# CONSTRUCTION TRAFFIC MANAGEMENT PLAN

Sydney Metro West – Western Tunnelling Package

Clyde/ Rosehill Site Establishment

# REVIEW COMMENTS SHEET

Figure 2-3: Existing sensitive receivers

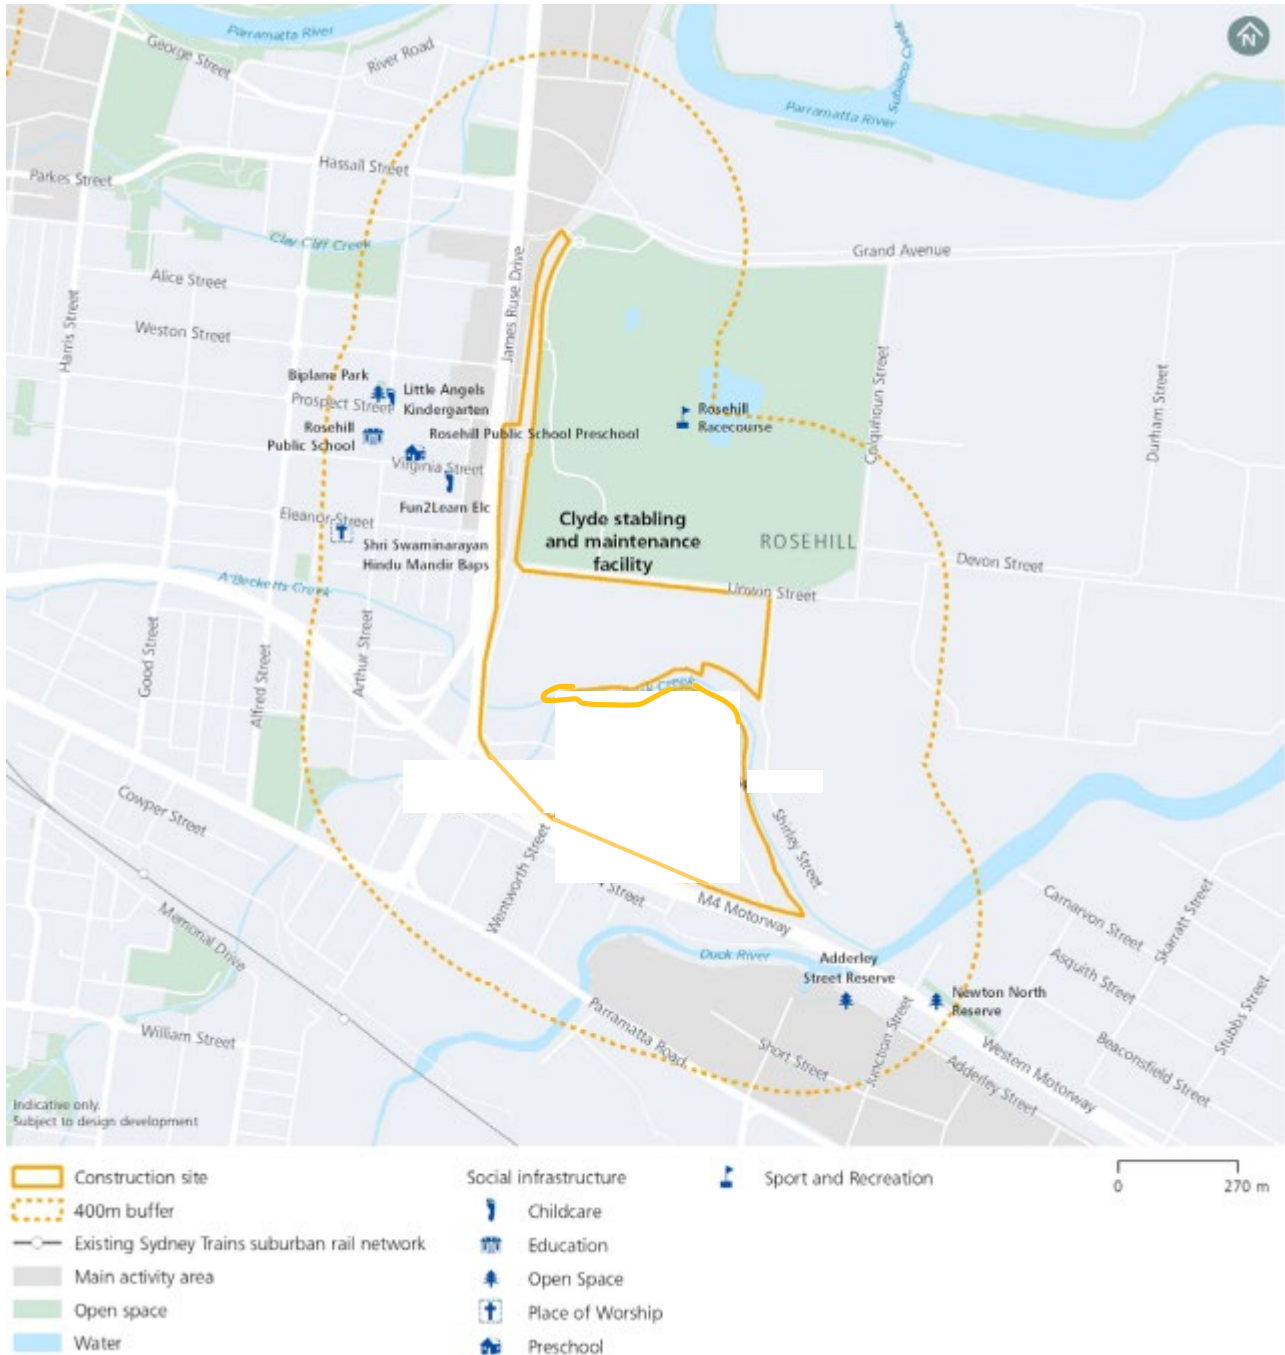
17	22/04/2022	SMD	ISUBRAMANI	SMWSTWTP-GLO-CLJ-TF-PLN-000001	figure 3 page 9	na	former sydney speedway -as Sydney Metro have acquired this land & facilitated their relocation.	Observation	N
							D KELLY	SMWSTWTP-GLO-CLJ-TF-PLN-000001	figure 3 page 9	na	Document amended	Observation	N
				18	22/04/2022	SMD	ISUBRAMANI	SMWSTWTP-GLO-CLJ-TF-PLN-000001	figure 4 page 10	na	What are the requirements for WTP to assess sensitive receivers and update since EIS?Remove references to sport and recreation within the project site. No longer relevant.	Observation	N
							D KELLY	SMWSTWTP-GLO-CLJ-TF-PLN-000001	figure 4 page 10	na	A land use survey is included as part of the detailed Noise and Vibration Impact Statement (SMWSTWTP-GLO-1NL-NL000-NV-PLN-000002). This is currently in draft and is being informed by construction from the EPA and other stakeholders. Throughout the construction period this document will be an evolving document.	Observation	N
